**TOWN OF WINTER PARK  
BOARD OF ADJUSTMENT  
Tuesday, October 14, 2025 8:00 AM  
Immediately following Planning Commission**

**TO** Board of Adjustment (BOA)  
**FROM** Brian P. Kelly, Senior Planner  
**THROUGH** James Shockey, AICP, Community Development Director  
**DATE** October 14, 2025  
**RE** PUBLIC HEARING: Appeal of Administrative Decision – BLD25-015  
(37 Cooper Creek Way, #315D) Plan Change Request

Re: Building Permit Plan Change Request for 37 Cooper Creek Way, Unit #315 D – Lots 1-3 Cooper Creek Square Subdivision (BLD25-015) - Winter Park, Colorado

Figure 2 East Elevation, street level railing not shown (1982)

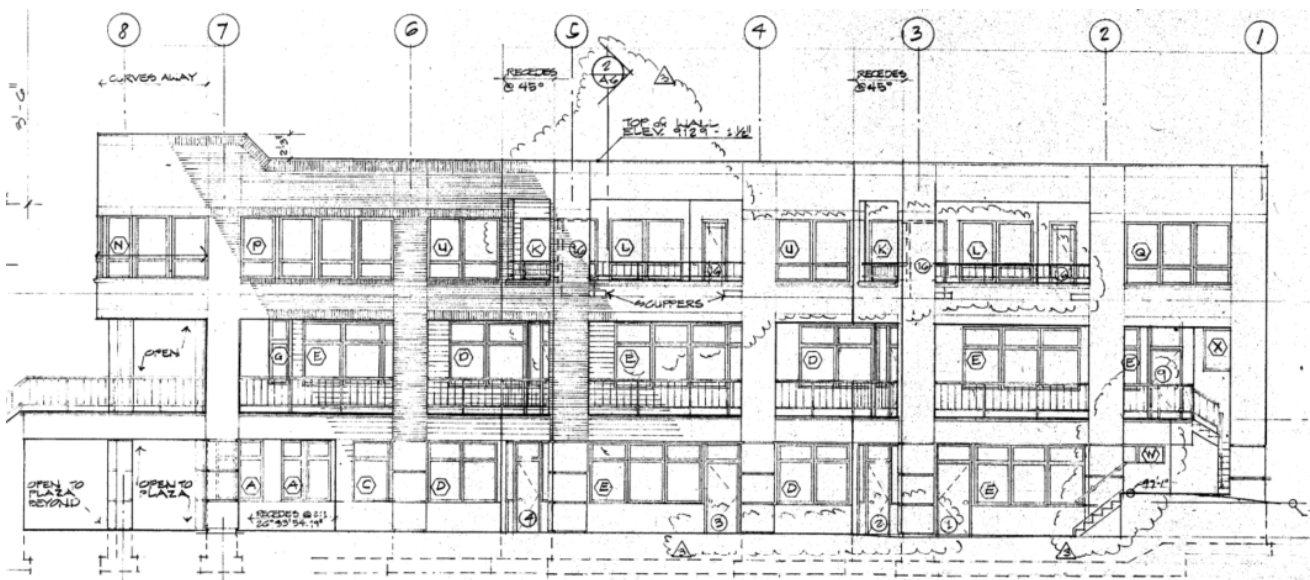
submitted in 2014 (the "2014 Proposal"). Figure 1 below, which was included in the 2014 Proposal, demonstrated a cohesive balcony design that matches the architecture of the entire Cooper Creek Square railing system.

The 2014 Proposal also stated, "Steel railings will surround the deck and all metal components will be painted to match the existing green of Cooper Creek Railings." Cooper Creek Railings were first proposed in 1982, and subsequent submittals showed a consistent rail design (Figure 2 below). Figure 3 below shows Cooper Creek Square railing details fabricated to match despite height variations on all three levels.

Figure 3 Railing Detail proposed design (1982)

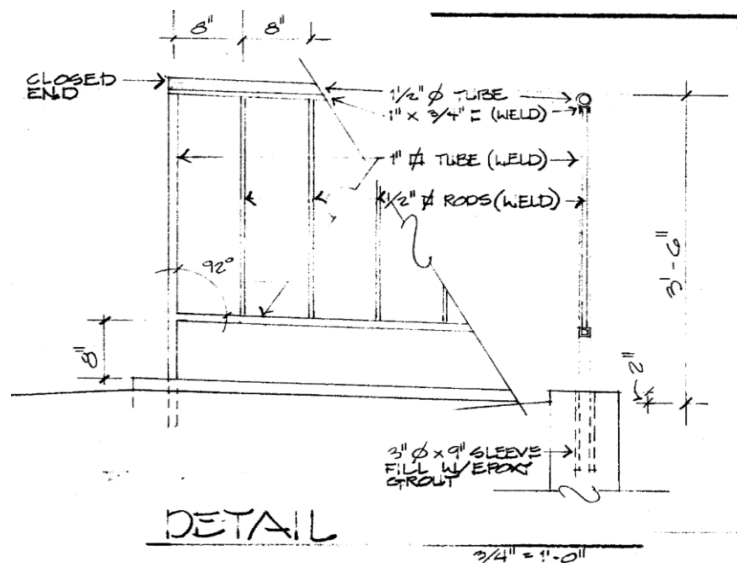
As shown in Figure 4 below, Applicant's Plan Change Request proposes a railing configuration that places wood slats in the space between the half (1/2) inch rods in the balcony area that is located in a prominent location above Cooper Creek Way and US Highway 40. Town staff is concerned that these wood slats are inconsistent with the rest of Cooper Creek Square.

While Town staff acknowledges that architectural diversity is an important design consideration throughout the Town and is discussed in the Winter Park Design Guidelines (the "WPDG"), there are no railings that currently exist within the Destination Center Zoning District (D-C) that are filled as proposed by the Applicant. Consistent railing designs contribute to Town wide connectivity between structures of different development periods. The WPDG provides enforceable principles that inform context sensitive designs. Notably, the Town considered WPDG § 1.1.3 *Connect to Nature*, WPDG § 1.1.4 *Engage with the Public Realm*, and WPDG § 2.6 *Fences and Walls*, which discusses designs that connect to nature, are sensitive to maintaining views, that interact with the street system, and incorporating a fence or a wall that maintains visibility to and from the street to enhance engagement.

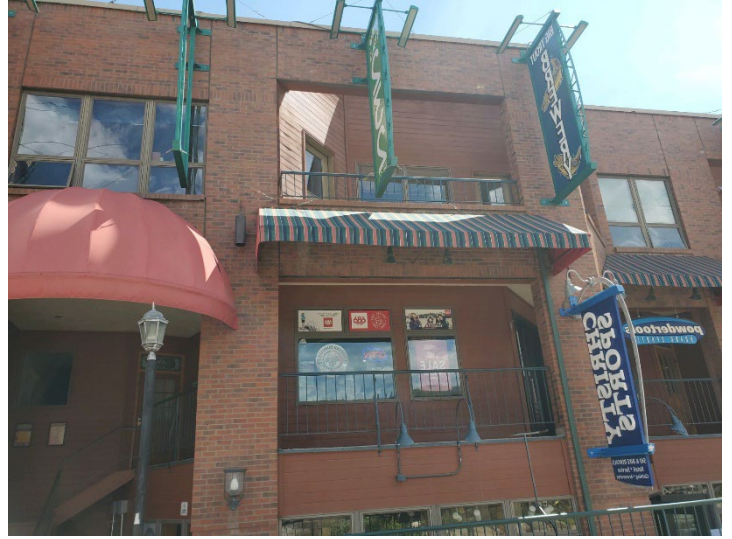
This first statement, “...few if any balcony screening is demonstrated within the D-C Zoning district”, is demonstrably false. From the above description and attached images of the six balconies always at Cooper Creek Square, our proposal is consistent with the design intent of Cooper Creek Square within the D-C Zoning District.

BALCONY PLAN

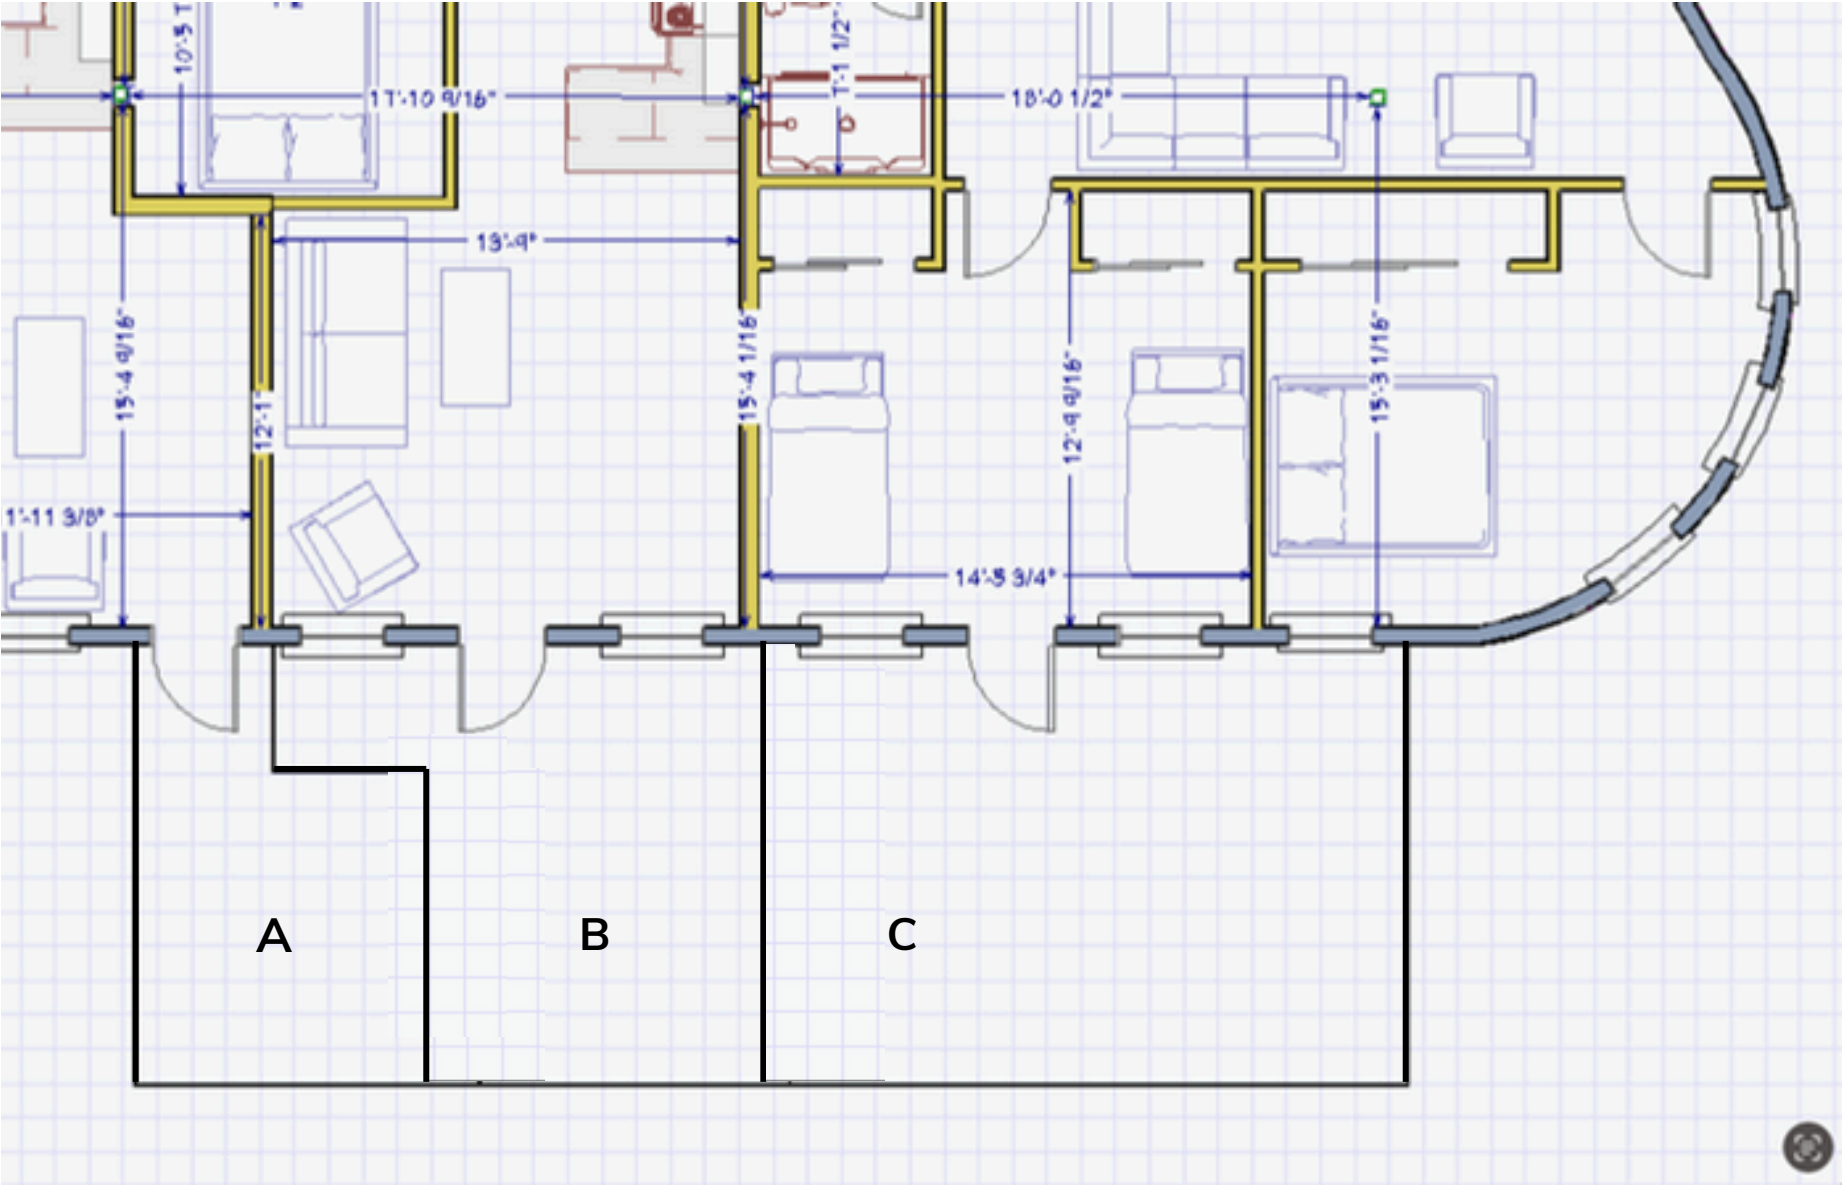
No vertical slats shall be installed between the steel rolled balusters of the existing railings as was originally proposed and constructed for Cooper Creek Square.

The Privacy Screen between units is an acceptable and approved change to the building permit (BLD25-015). The framing must be painted to match the railing as described "Cooper Creek Green", the vertical slats will be painted "Cooper Creek Red".
